City of Sebastopol Design Review Board/Tree Board Staff Report

Meeting Date: December 21, 2022
Agenda Item: 7B
To: Design Review Board
From: John Jay, Associate Planner

Subject: Preliminary Review
Recommendation: None
Applicant/Owner: Kathy Austin/Pacific Realty Development
File Number: 2022-086
Address: 7621 Healdsburg Ave
CEQA Status: To be determined
General Plan: High Density Residential/Commercial Office
Zoning: Multi-Family Residential (R7)/Office Commercial (CO)

PROPOSED CONDITION

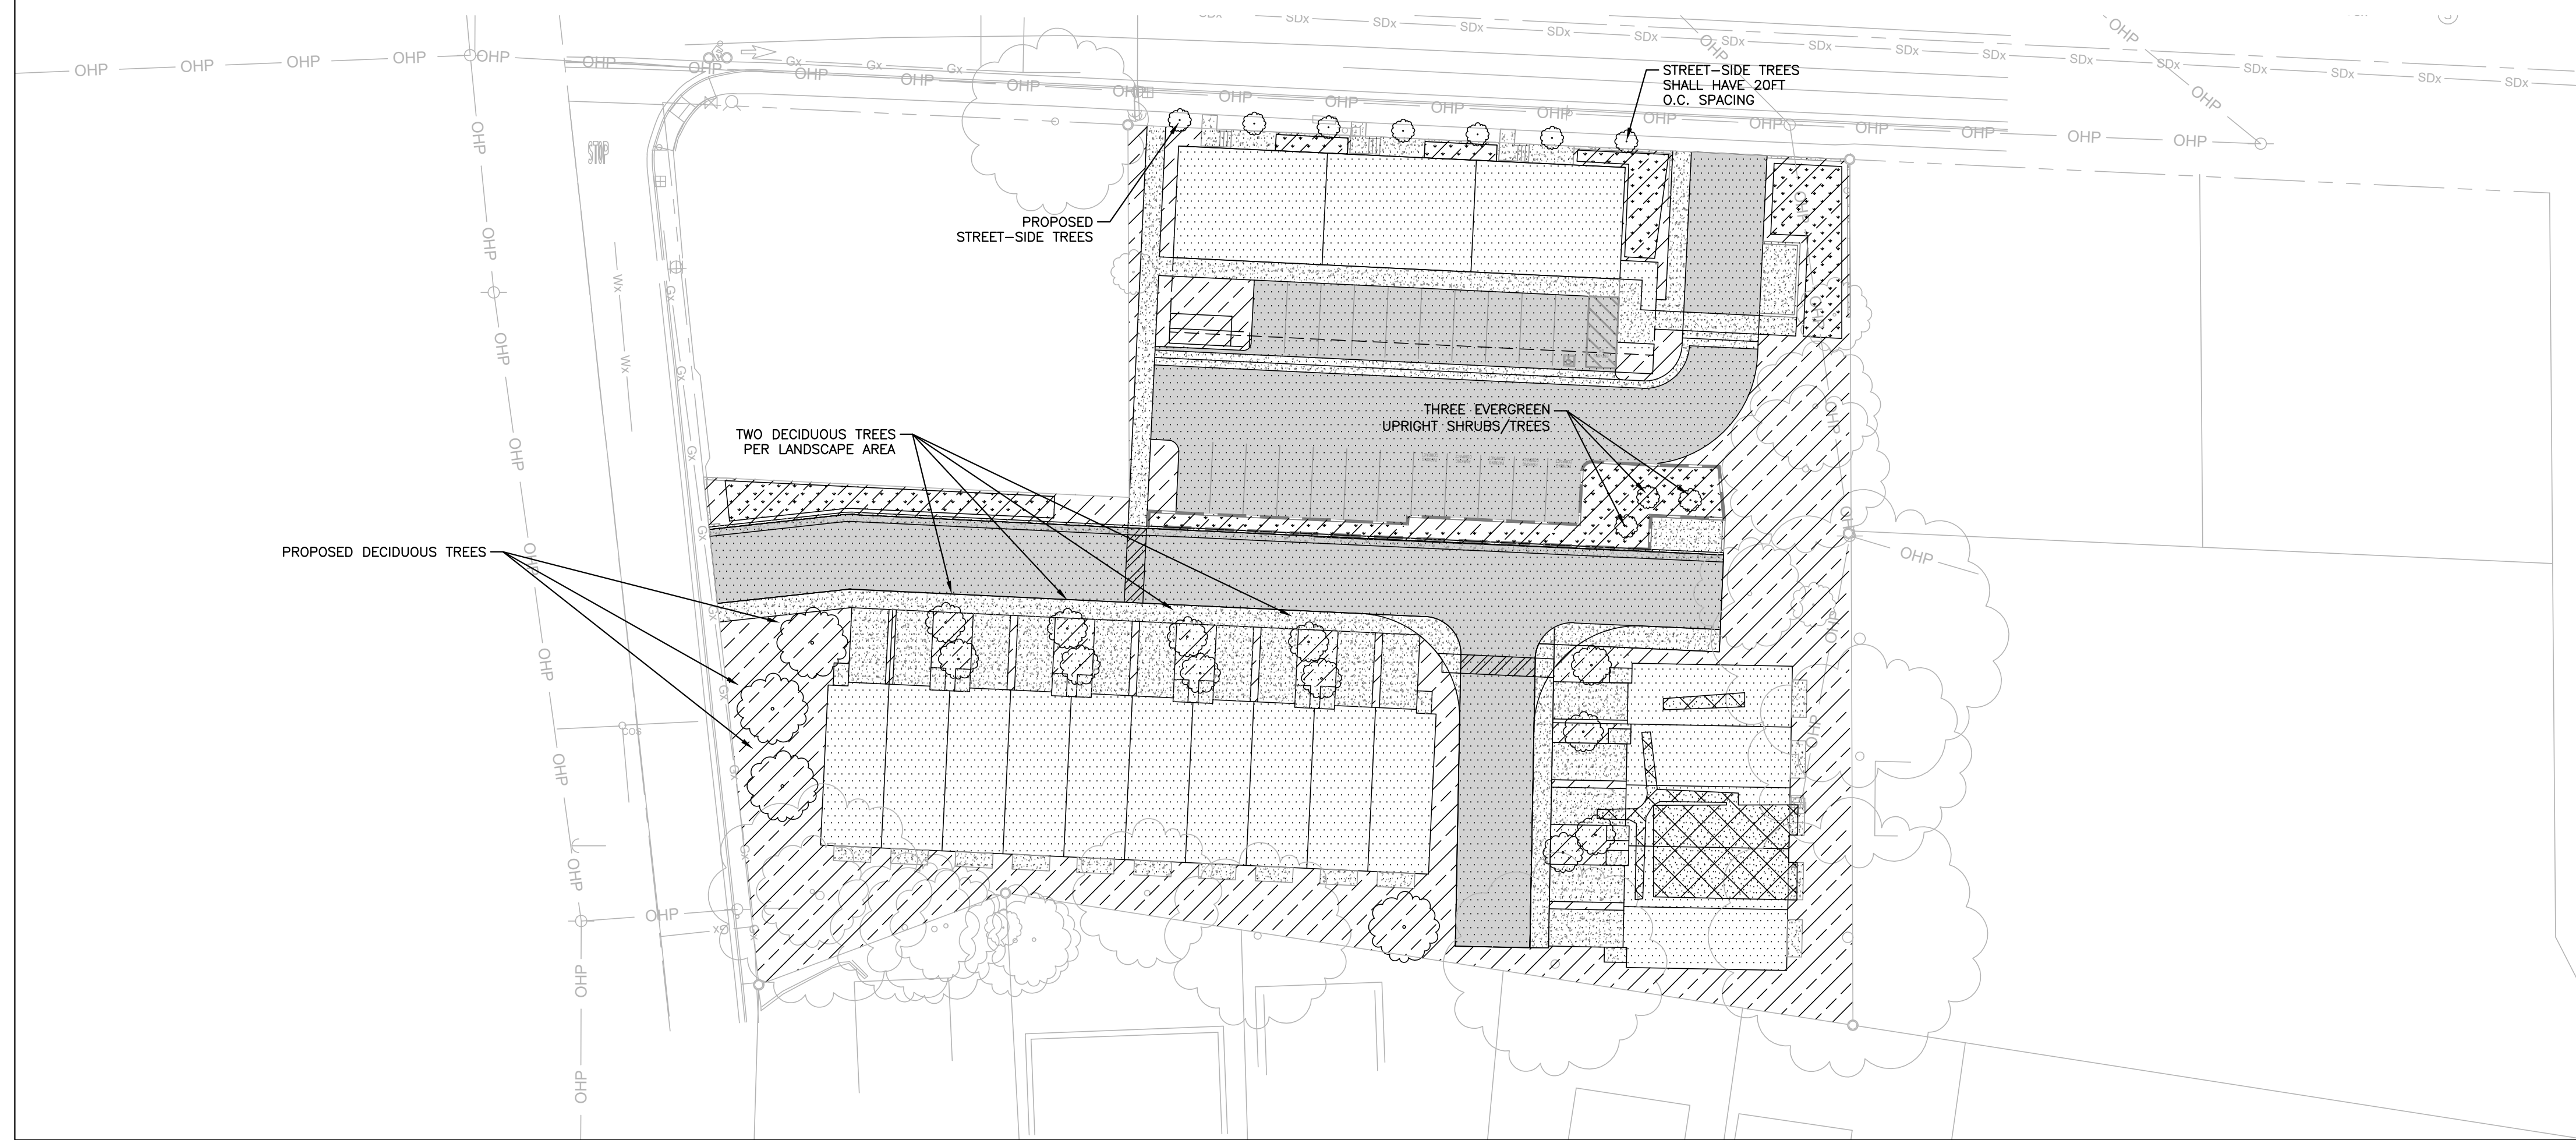
No decision on the project will be made at this meeting. However, the applicant is requesting feedback from the Design Review Board on the scope of the project. In particular, staff requests the Design Review Board discuss the following areas and provide feedback to the applicant and staff:

- Grading work on site.
- Impervious surface and how to best mitigate the amount of it.

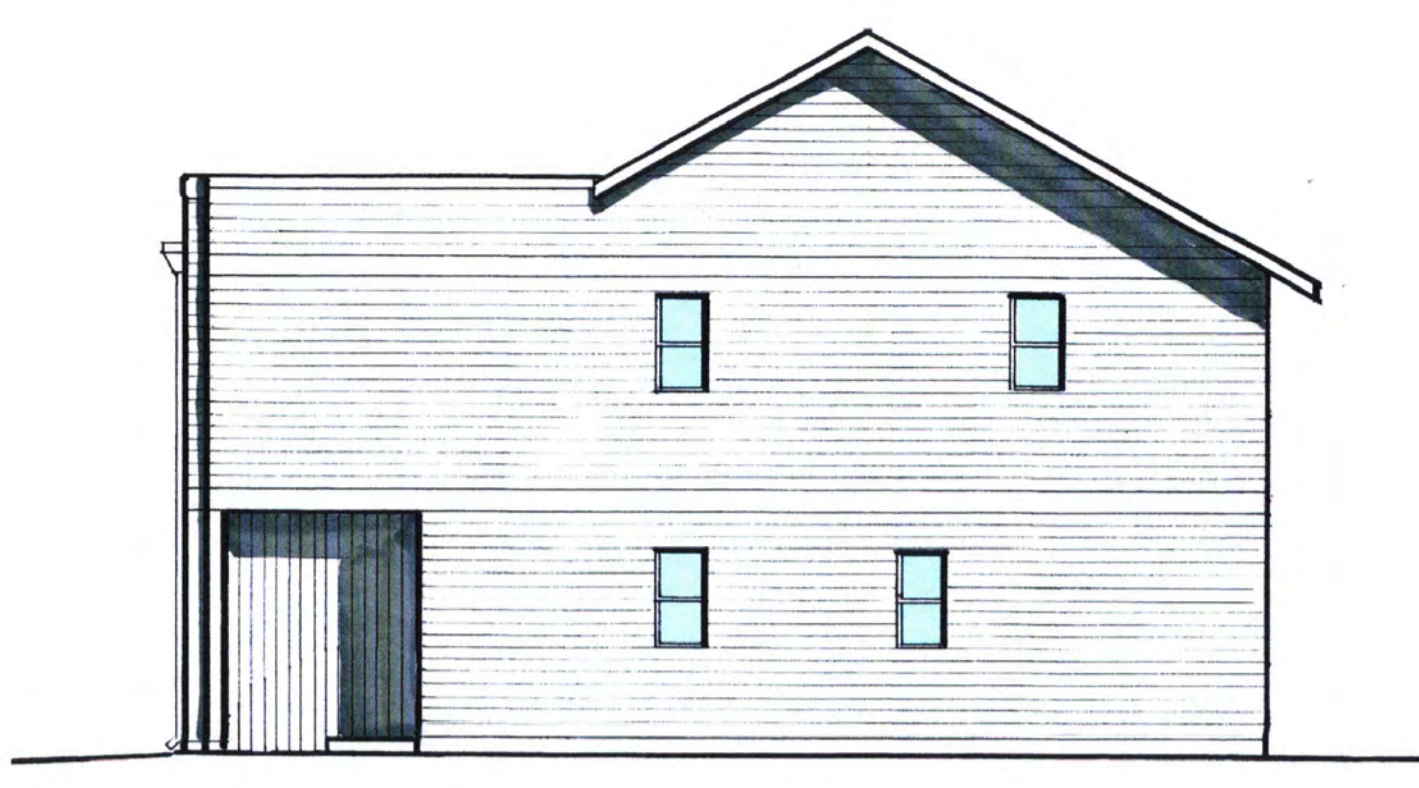
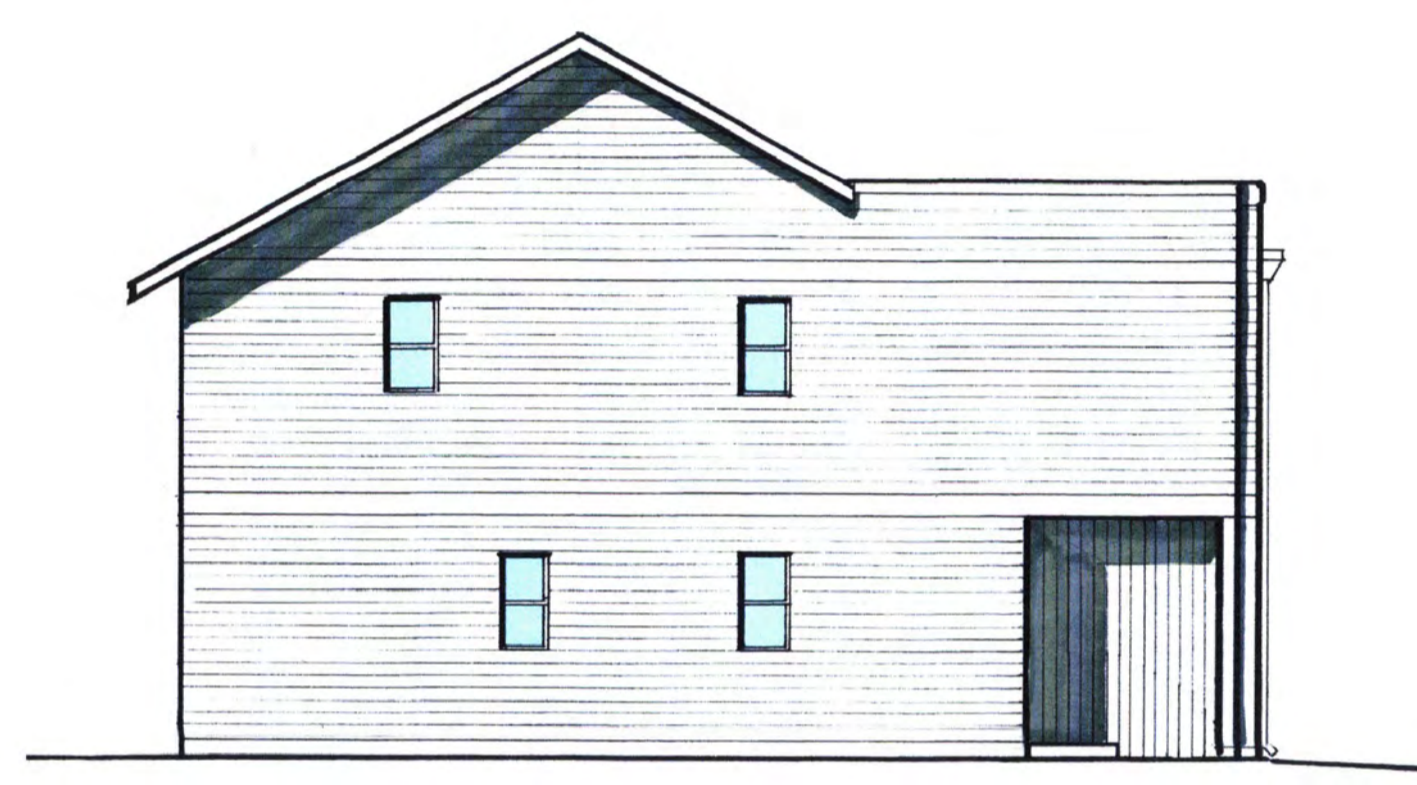
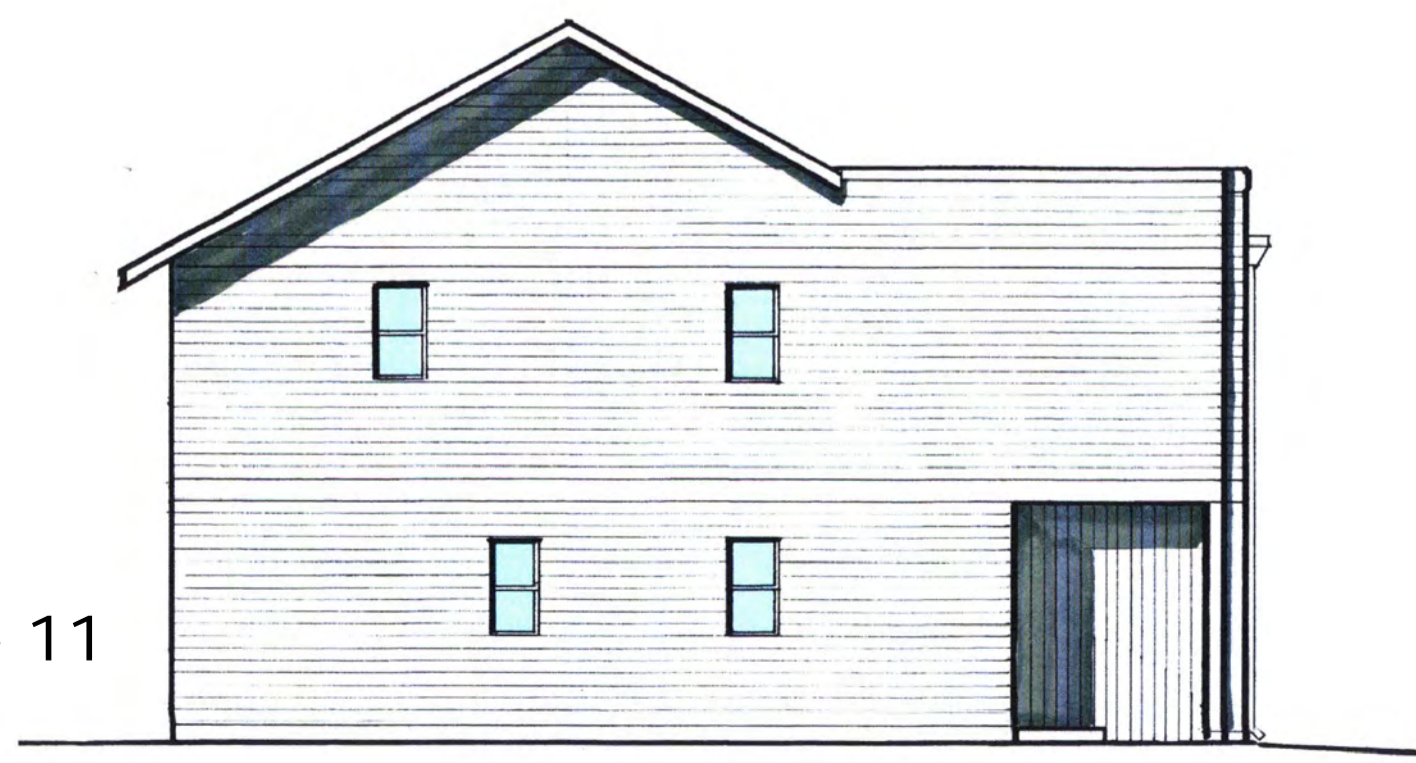
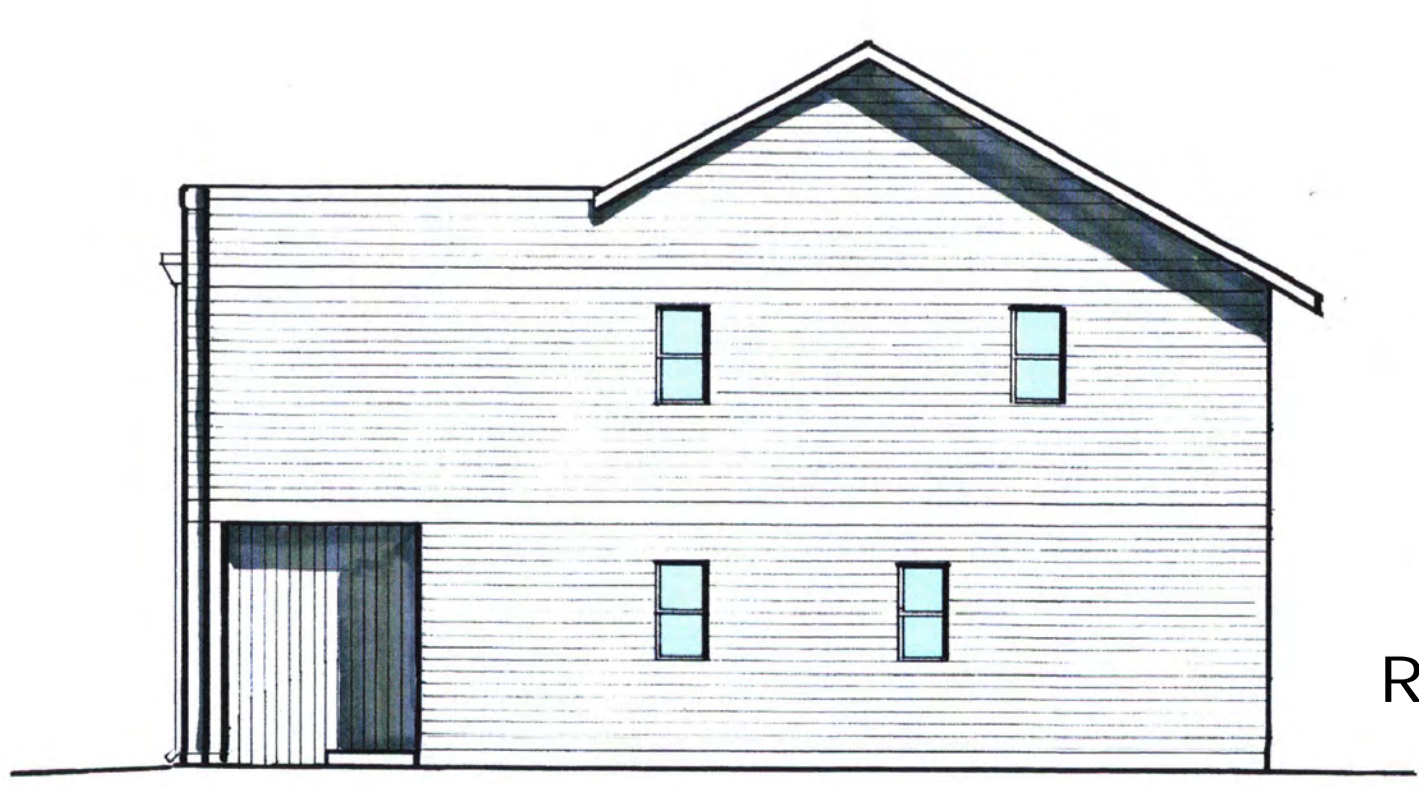
The proposal for the townhomes is designed in a way that steps the roof lines up and down the building. As the townhomes are attached, the massing of the buildings incorporates window pop outs to break up the block like façade. The townhomes are proposed with composite style roofing and the building facades are a mix of vertical cedar and cement board siding. As these are still preliminary plans the solar design but the commercial building does show rooftop mounted solar on the flat roofs that would not be visible from the street. However, the townhome

solar is not defined in the plans provided and staff is concerned that the only possible location would be the street facing part of the roofs.
